St. Lucie Units 1 and 2
Docket Nos. 50-335 and 50-389
Proposed License Amendments
Addition of Cask Pit Spent Fuel Storage Racks
Technical Specification Requirements

L-2002-187
Attachment 1
Page 1 of 33

EVALUATION OF PROPOSED TS CHANGES

FIGURE 5 6-1f

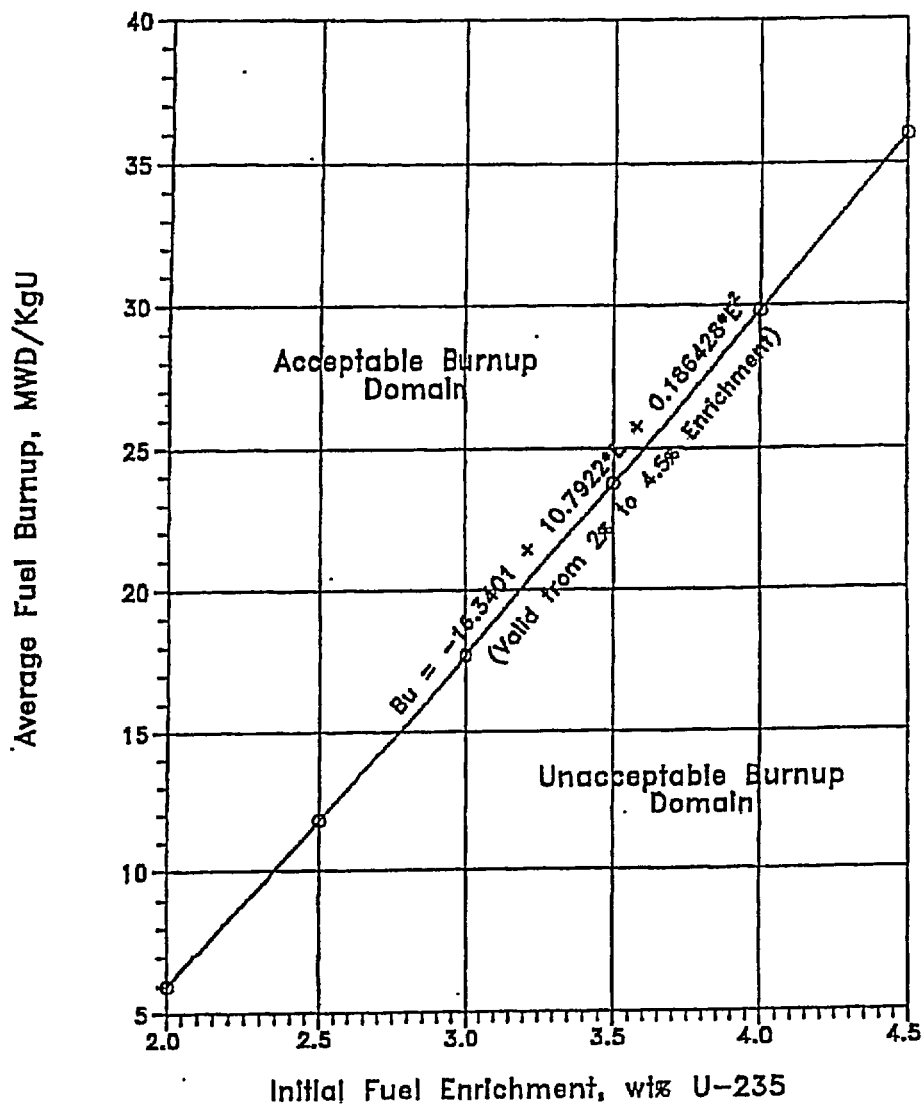
- c. Section 5.6.1.c.1 is revised to read: "Fuel placed in the Region II **spent fuel pool storage racks** shall meet the burnup and decay time requirements specified in Figure 5.6-1a or 5.6-1b. **Fuel placed in the Region II cask pit storage rack shall meet the burnup requirements specified in Figure 5.6-1f.**"

- e. Add new Figure 5.6-1f, "Required Fuel Assembly Burnup vs Initial Enrichment, Region II Cask Pit Storage Rack."

Fuel placed in the Region II cask pit storage rack shall meet the burnup requirements specified in Figure 5.6-1f.

FIGURE 5.6-1f

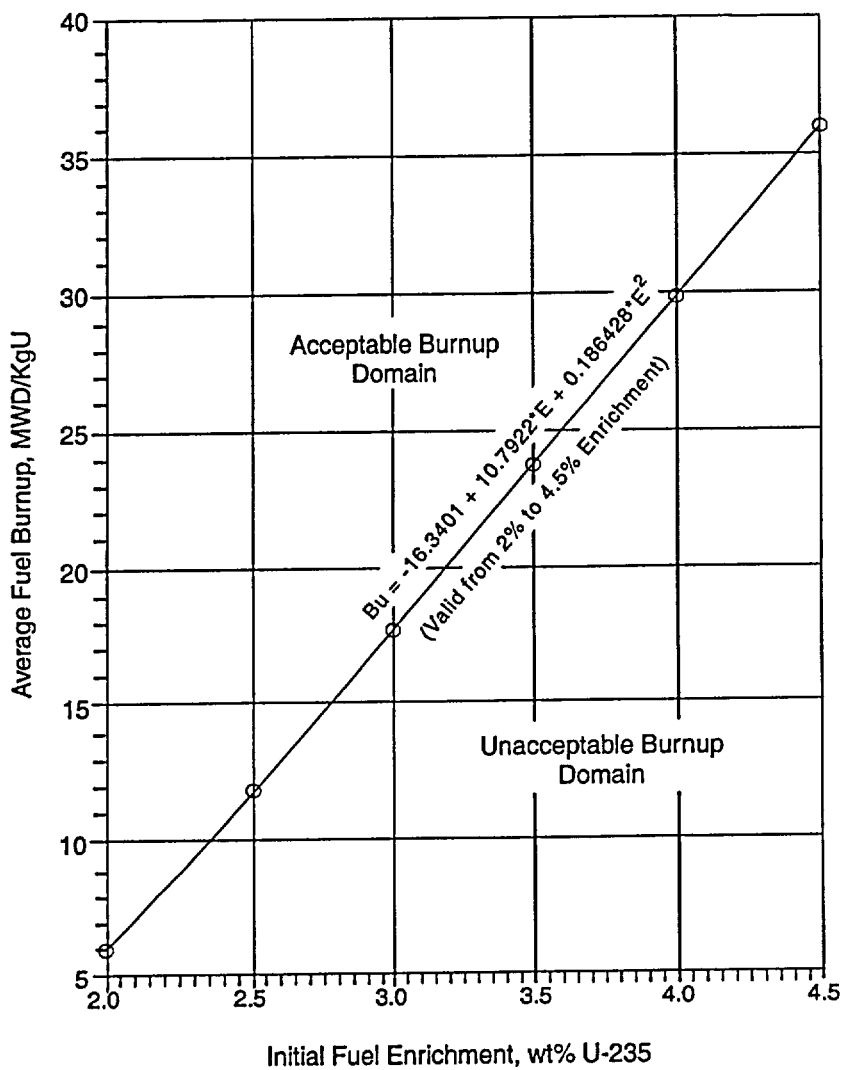
Figure 4.2.1 in Enclosure 2 provides the minimum burnup level to satisfy the cask pit rack criticality analysis results for any fuel enrichment value between 2 and 4.5 weight percent. The acceptable burnup domain identified in Figure 4.2.1 is incorporated into new Unit 2 TS Figure 5.6-1f.

1. Fuel placed in the Region II spent fuel pool storage racks shall meet the burnup and decay time requirements specified in Figure 5.6-1a or 5.6-1b. Fuel placed in the Region II cask pit storage rack shall meet the burnup requirements specified in Figure 5.6-1f.
